FACILITY POST-EXAMINATION COMMENTS

FOR THE PALISADES INITIAL EXAMINATION - MAY 2005

Initial License Examination Comments

PALISADES INITIAL LICENSE EXAMINATION COMMENTS

1. PPC trend page from reactor trip report dated 07/21/98 with TBV available.
2. PPC trend page from simulator reactor trip with TBV available.

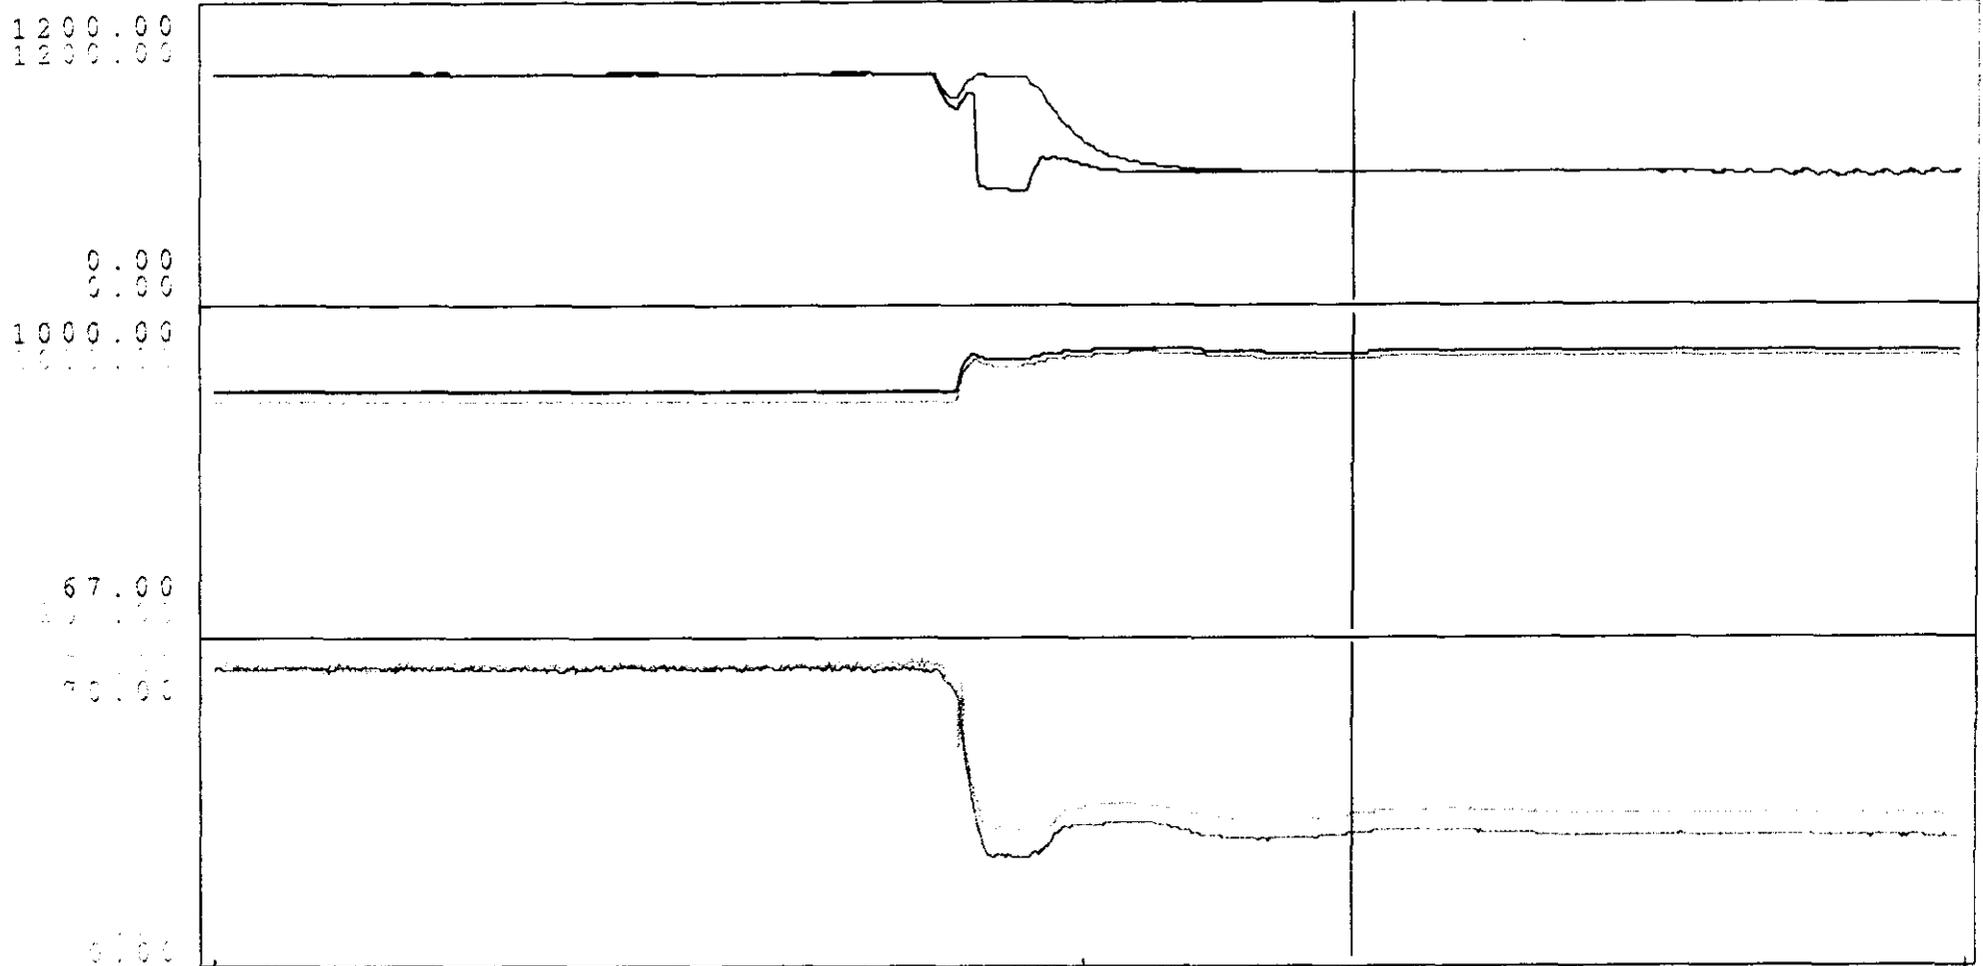
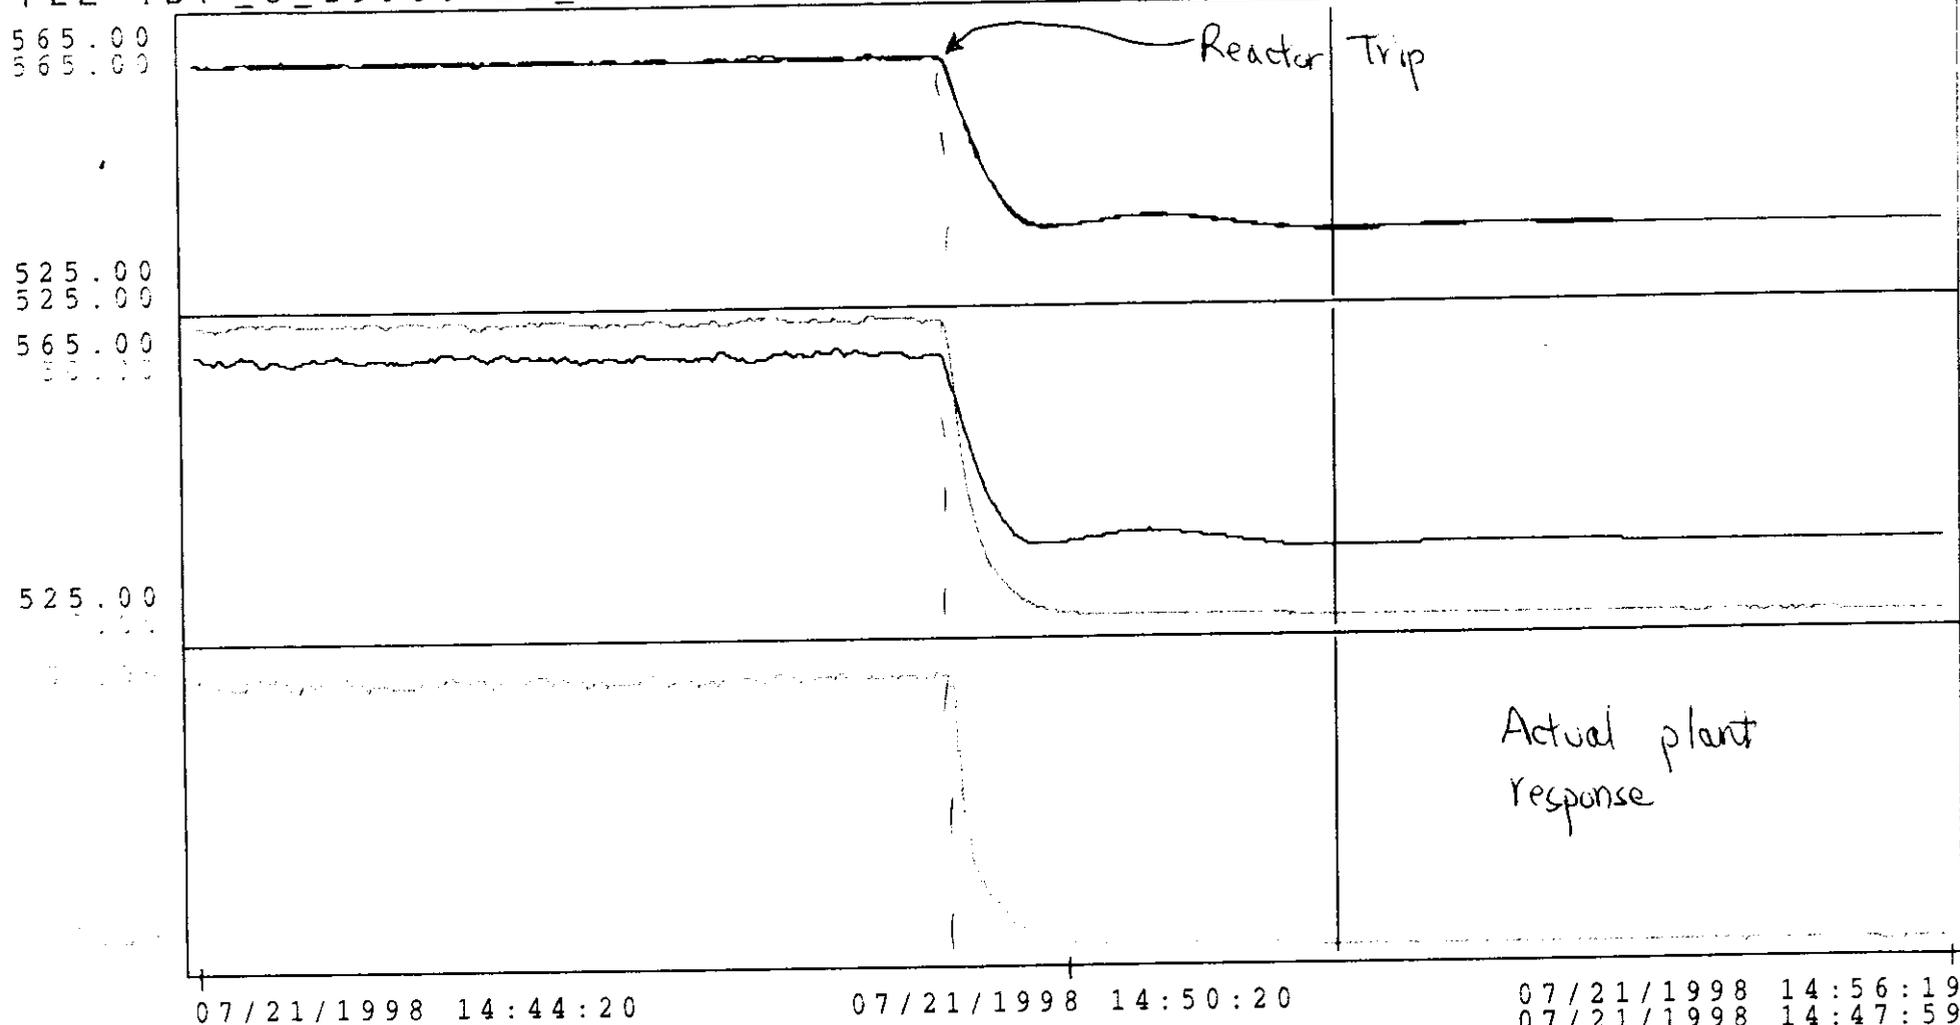
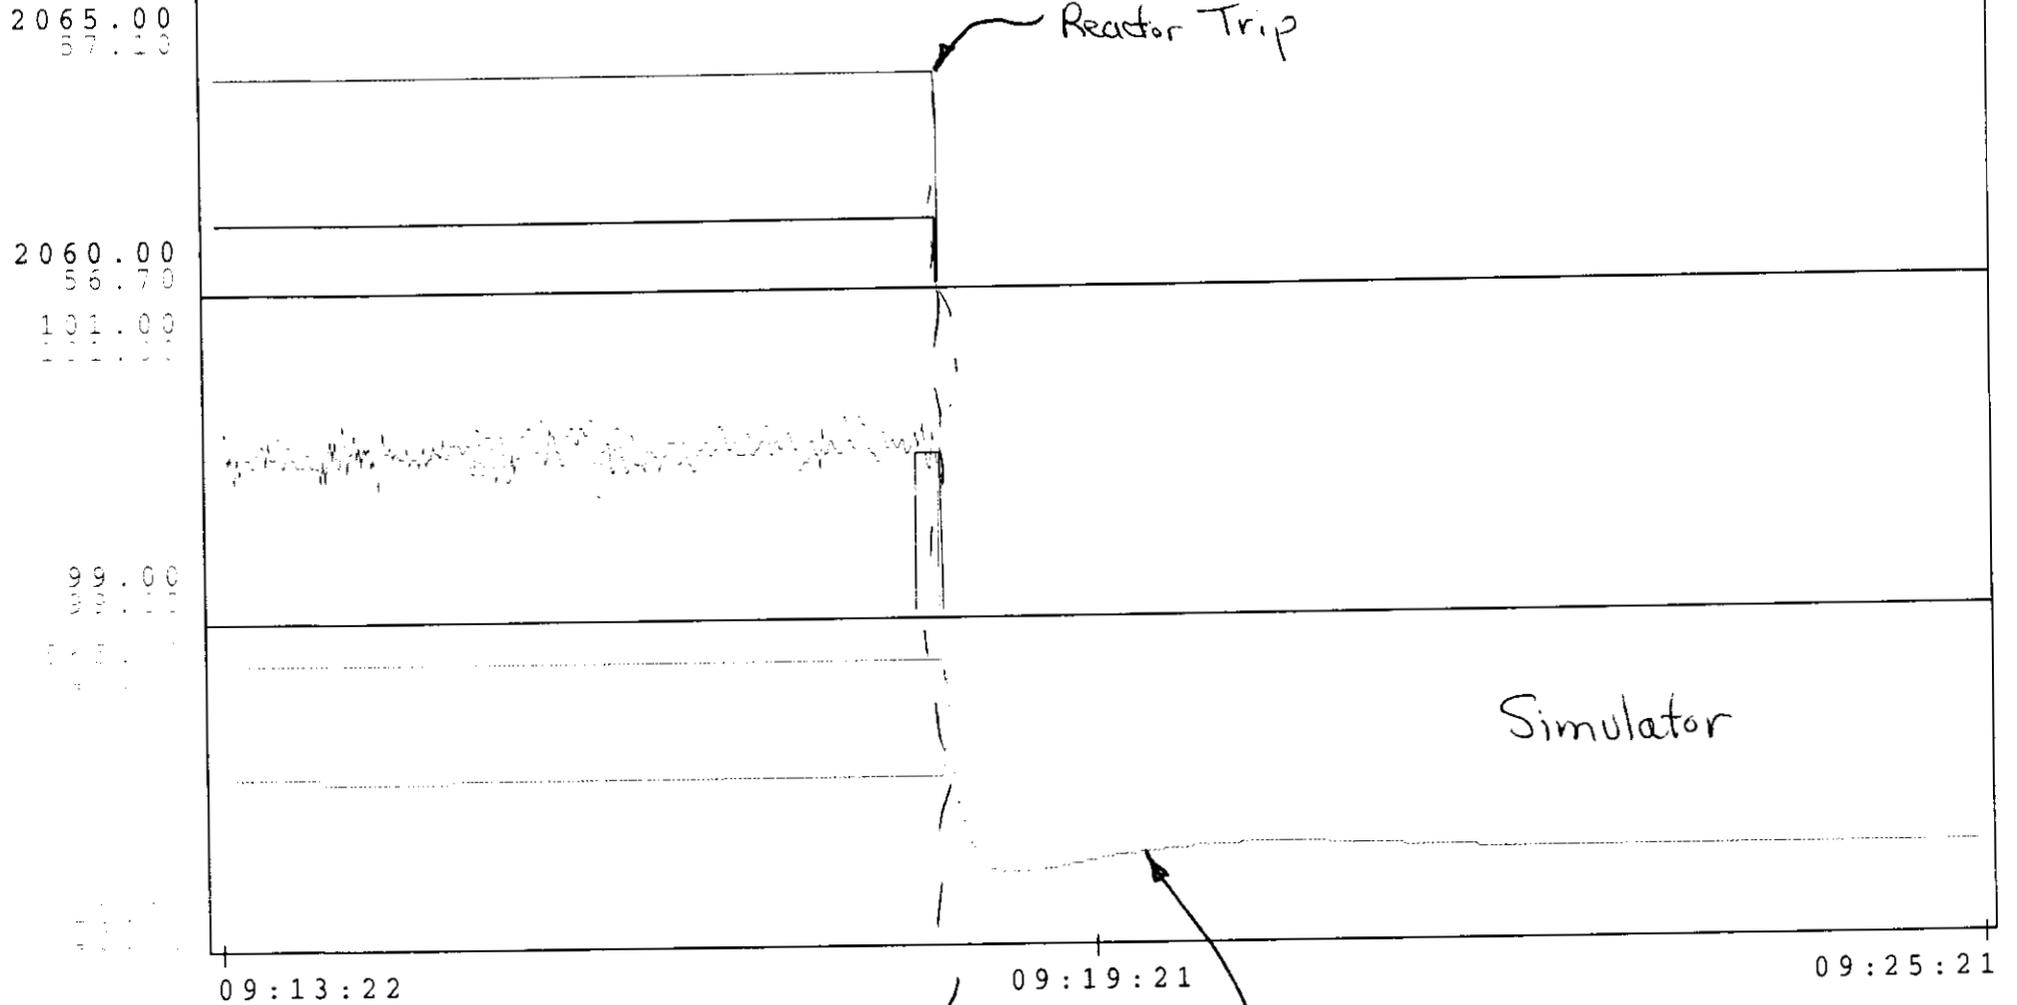
The question stem asks, "what would PCS temperature be." The briefing provided to the candidates just prior to the exam, in accordance with Appendix E of NUREG 1021, Rev. 9, instructed them to answer all questions based on actual plant operation, procedures, and references, and that if they believe the answer would be different based on simulator operation or training references, they should answer based on the *actual plant*.

By design, the turbine bypass valve (TBV) does control main steam header pressure at 900 psia (531.95 degrees F at saturation). However, pressure losses between the main steam header and the steam generators, along with efficiency losses in the steam generators, result in a stable Tave of slightly less than 535 degrees F.

This question and answer B reflect system design, but not actual plant response. Please see attached copies of both actual plant data and simulator response that show that actual PCS temperature (Tave) stabilizes at approximately 535 degrees F with the turbine bypass valve available.

Facility Recommendation: Change correct answer to D.

1. System Operating Procedure SOP-2A, Attachment 2, Pressurizer Level Control Table

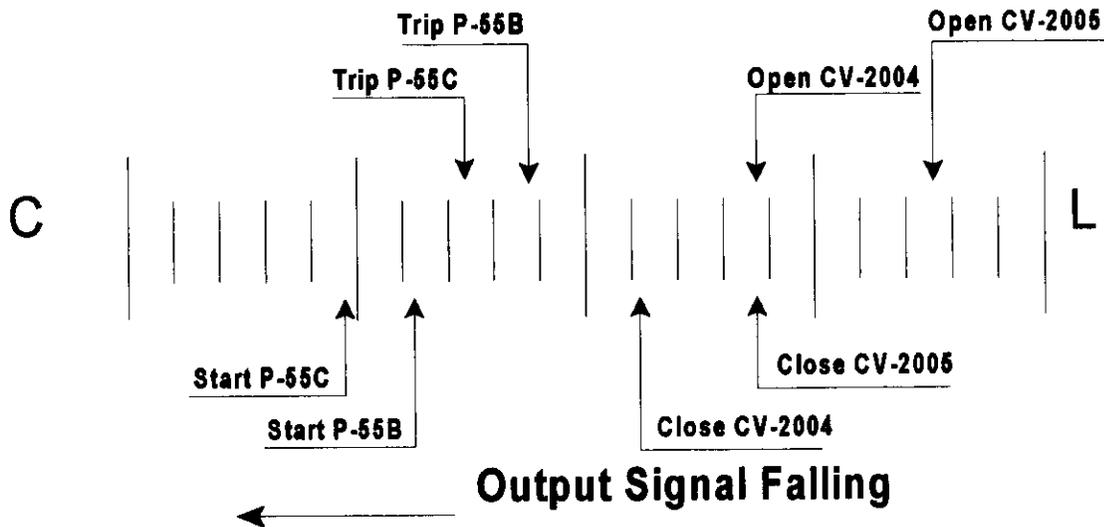
This question has no correct answer. The correct answer was selected originally based on an understanding of the backup pressurizer level control system design, specifically, that it controls in an approximately 11 percent band. However, with the pressurizer level control malfunction standing, the pressurizer level will actually oscillate over a 2 percent range, the range between where the backup program takes control (~-6%) and where it gets a signal to reset (~ - 4%).

Facility Recommendation: Delete question from exam since no correct answer is provided.
